# **HELIOS RENEWABLE ENERGY PROJECT**

## **FLOOD RISK ASSESSMENT**

## Helios Renewable Energy Project Revised Scoping Document

JBA Project Code 2022s0454  
Contract  
Client  
Day, Date and Time  
Author  
Subject Helios Solar Farm FRA methodology review

Figure 1: Existing Model Coverage

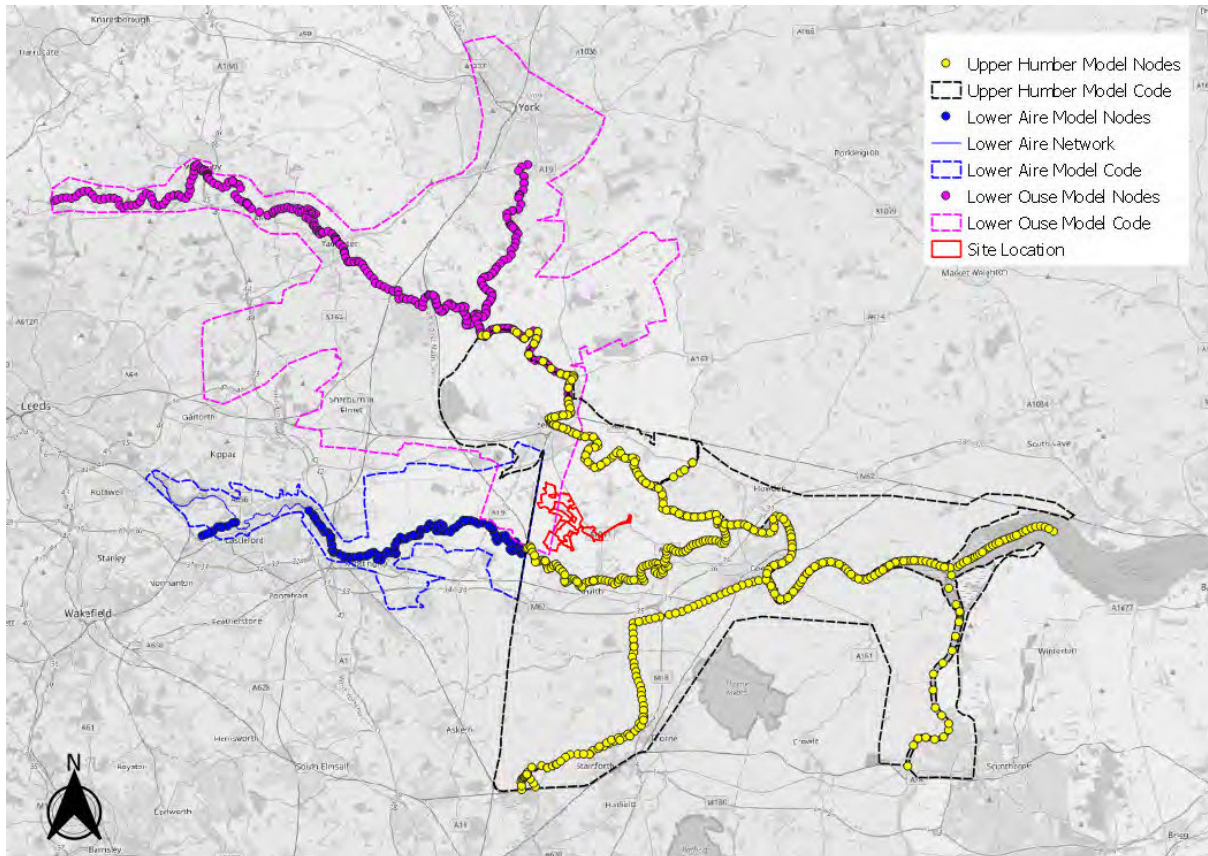
There are three models which cover the watercourses - The Upper Humber (2016) and Lower Aire (2017). The 1D nodes and 2D model codes associated with these models are shown in Figure 1 below.

It is proposed to use the Upper Humber (2016) model as the primary model and extend the Ouse and Aire watercourses upstream as necessary using geometry from the Lower Aire and Lower Ouse models. Superfluous downstream tributaries not thought to influence flood risk at the site will be removed to reduce model simulation times.

**Figure 2: Datasets used to define the water level profile on the Humber estuary and its tidal tributaries**

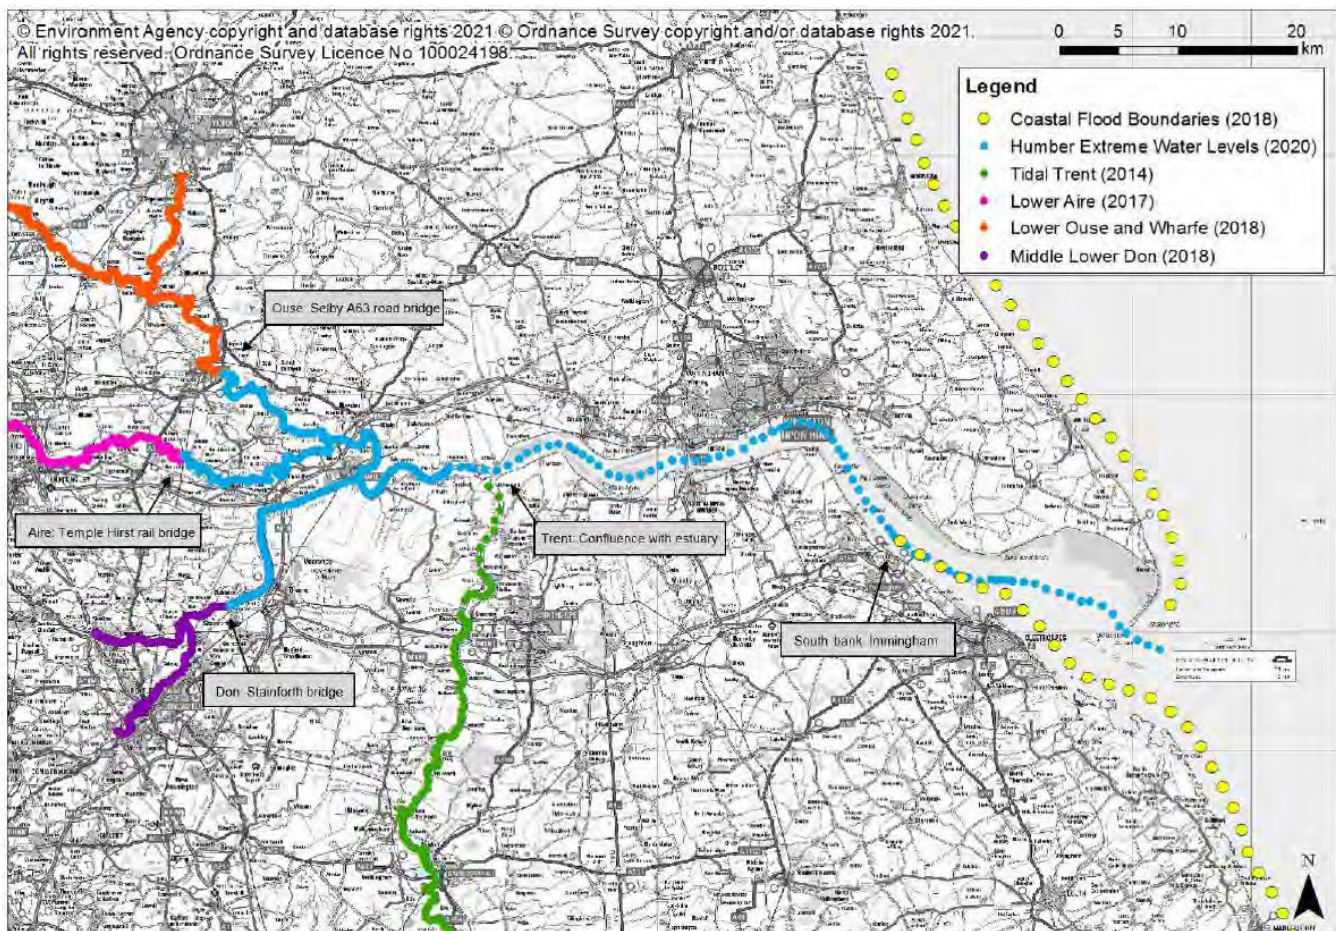
The FRA project should make use of the HEWL project. Whilst the Upper Humber and Lower Aire model are likely to include more detail in terms of local topography compared to the HEWL 1D only model, the HEWL supersedes the boundary conditions of these older models. It is recommended that Aegaea revisit the modelling methodology with the HEWL included. The update should consider the relevant merits of each of the three models / projects and identify how each can be used to offer the best representation of flood risk at the site.
